AGREEMENT NO. CE3/2016(CE)
SECTION 16 PLANNING APPLICATION
FOR MULTI-STOREY BUILDING DEVELOPMENTS NEAR YUEN LONG INDUSTRIAL ESTATE

Section 16 Planning
Application for Multi-storey
Building Developments at No.
32 Wang Lee Street and
Adjoining Government Land,
Yuen Long

Figure 4.25: Layout Plan of Proposed Scheme with indications of good design features

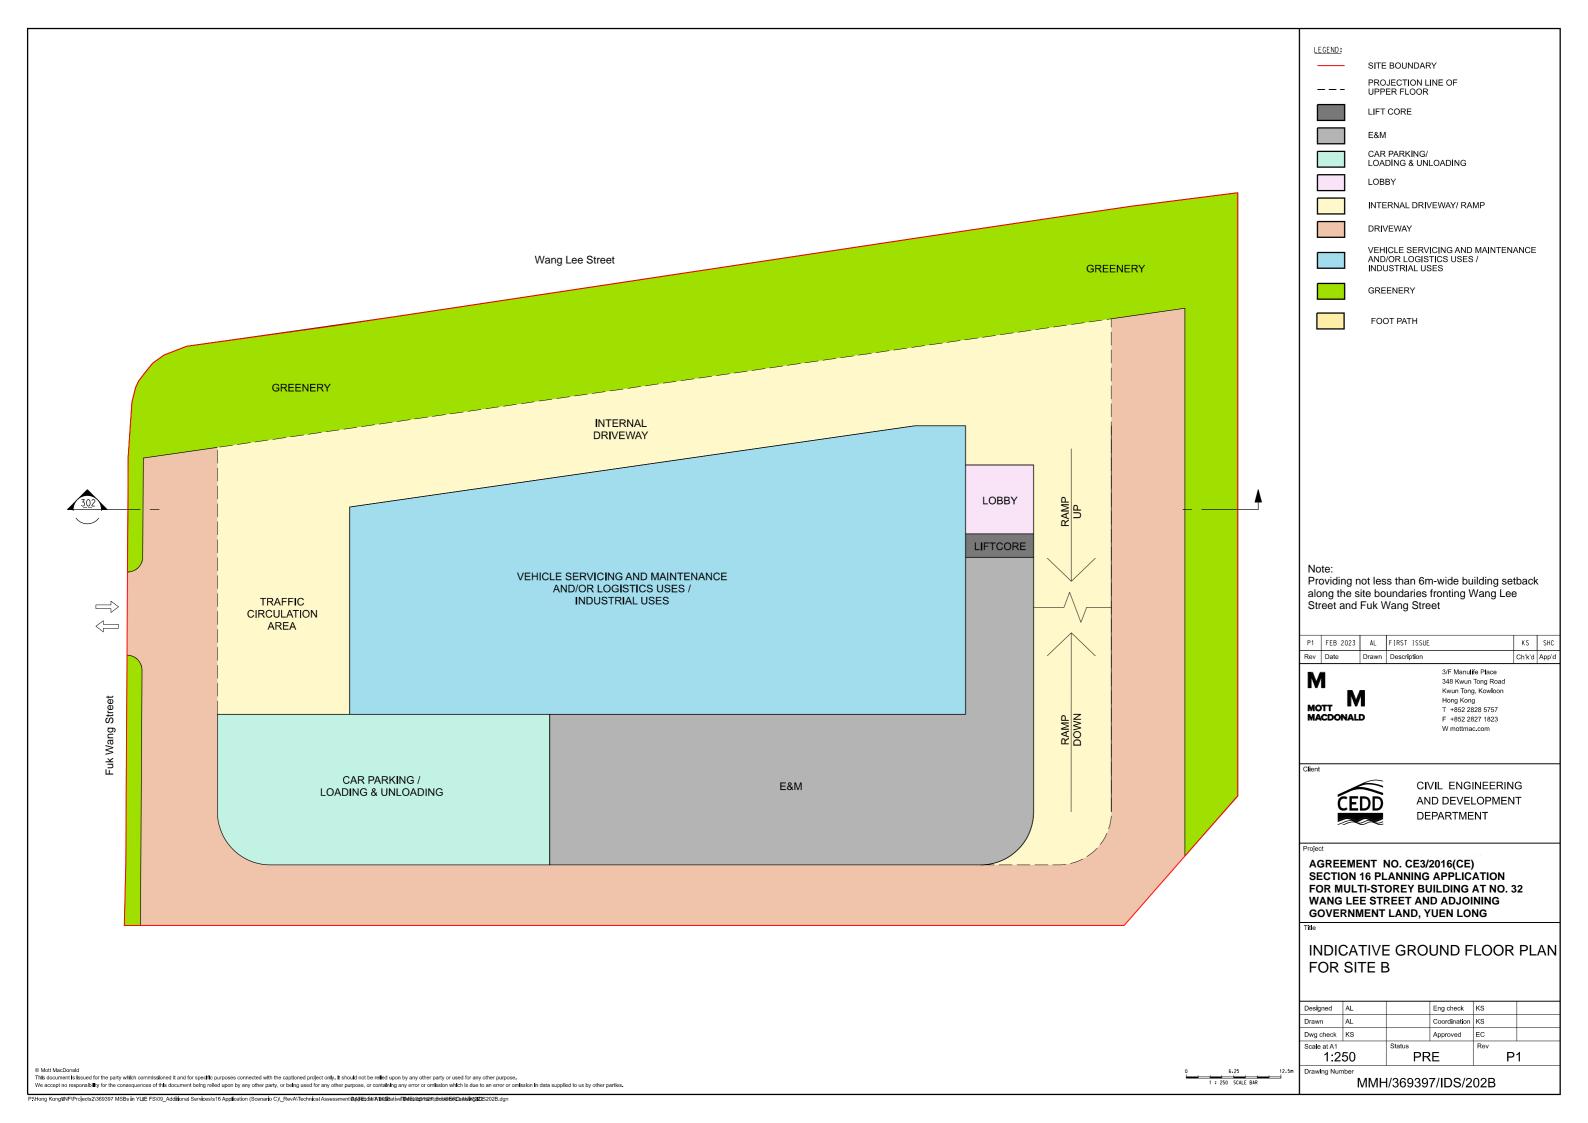
5.4.	Appendix H (AVA IS Report)  3. Proposed Building setbacks (paragraph 4.8.1, 2nd bullet) – Referring to Figure 4.25, the consultant should report the proposed 13.3m-wide building setback from the south-western site boundary of Site A in text.	Paragraph 4.8.1, 2nd bullet has been revised.

5.5.	<ol> <li>Proposed Empty bays (paragraph 4.8.1, 3rd bullet) – For complete information, the consultant please refer to Figure 4.25 for the exact dimension of the proposed ground floor empty bays.</li> </ol>	Paragraph 4.8.1, 3rd bullet has been revised.
